REMARKS

The Office Action mailed May 3, 2006 has been carefully considered. Reconsideration in view of the following remarks is respectfully requested.

In the Drawings

The attached replacement and annotated sheet(s) of drawings include changes to FIGS. 12B, 18 and 19 as follows:

FIGURE 12B

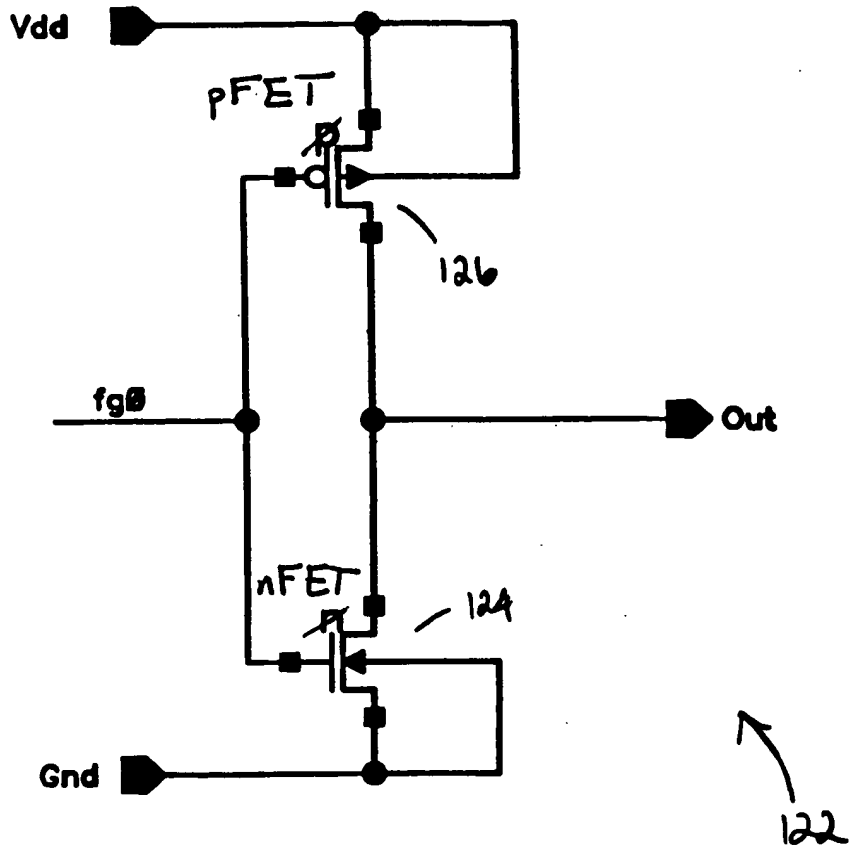
FIG. 12B has been amended to add the designations pFET and nFET.

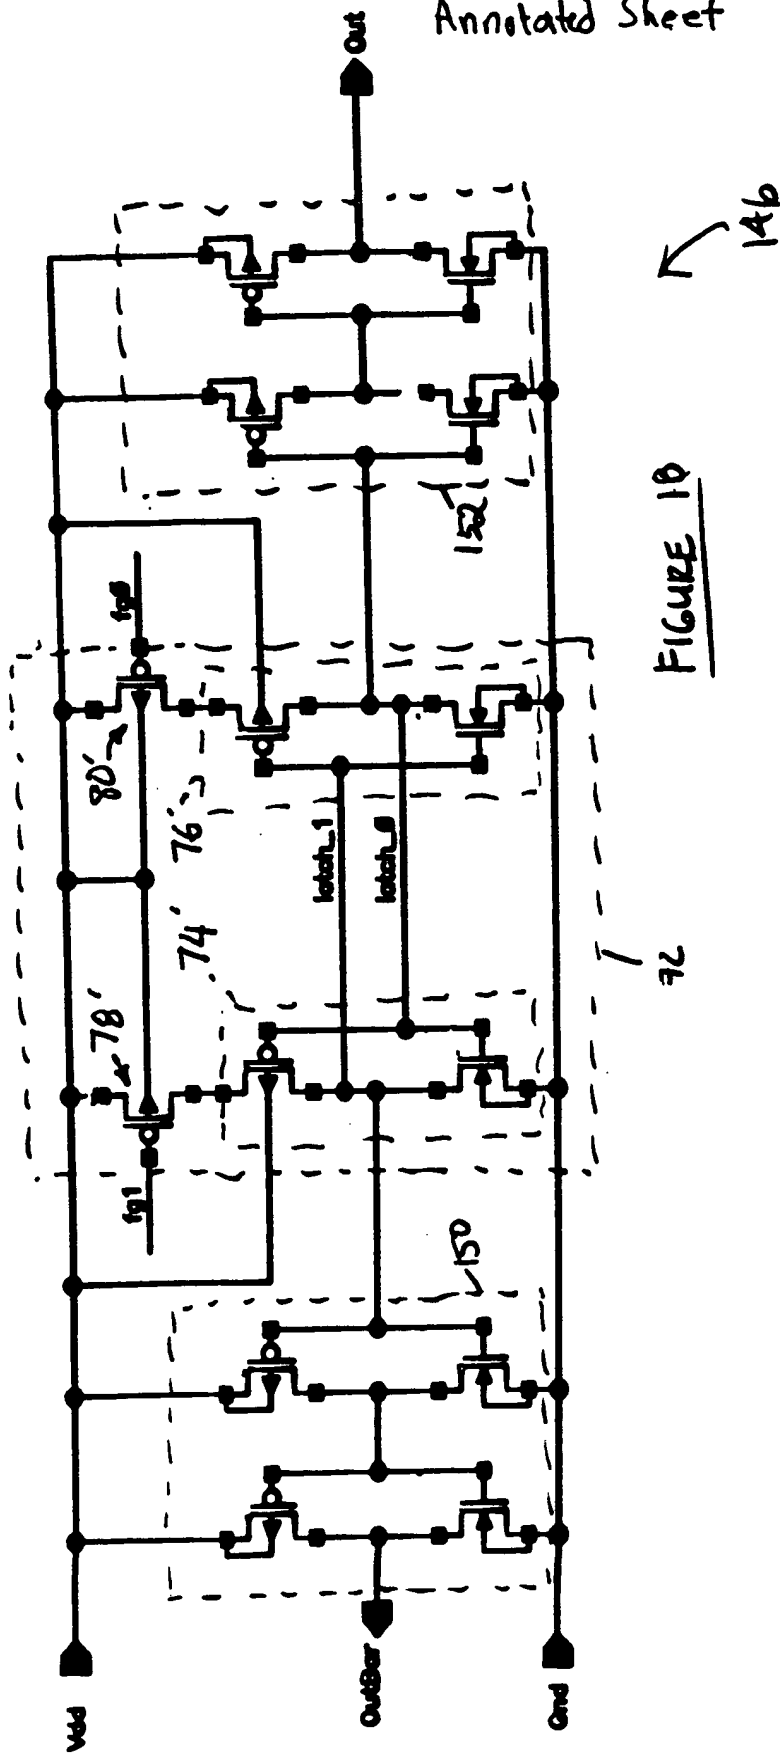
FIG. 18 has been amended to add the designations 74', 76', 78' and 80'.

FIGURE 19

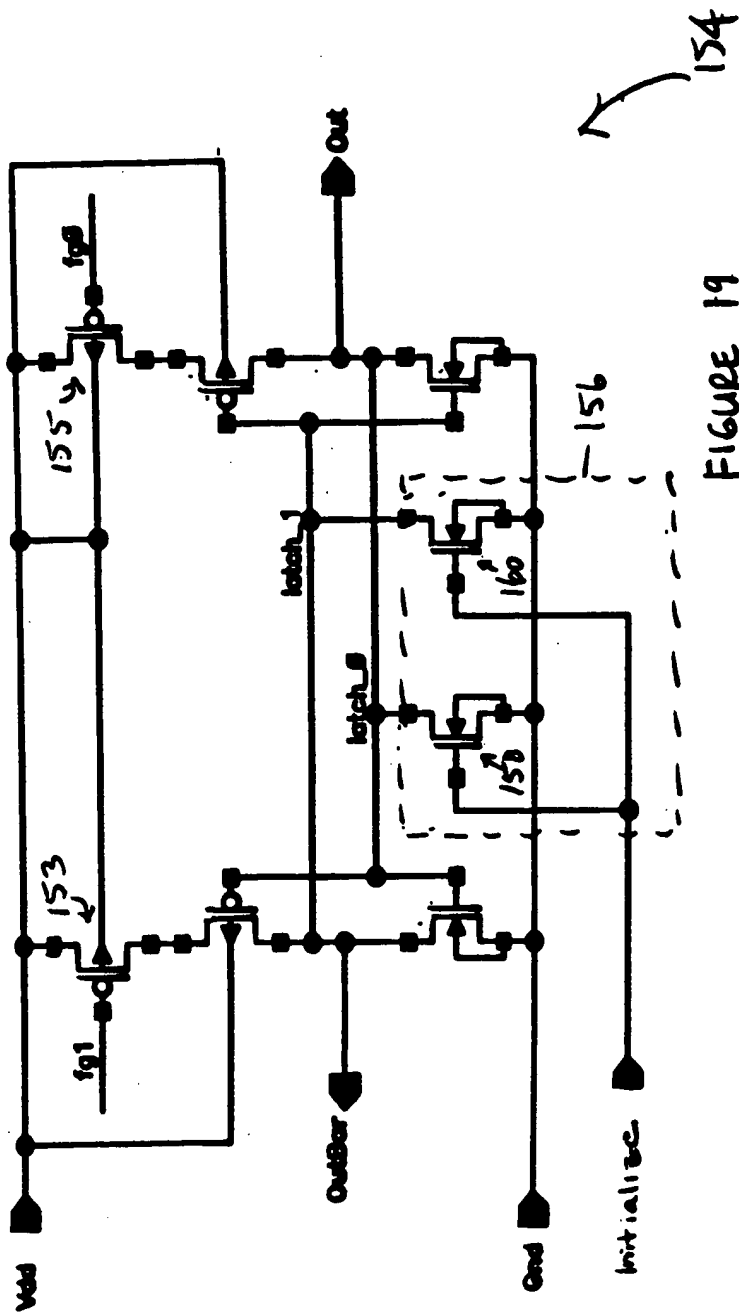
FIG. 19 has been amended to add the designations 153 and 155.
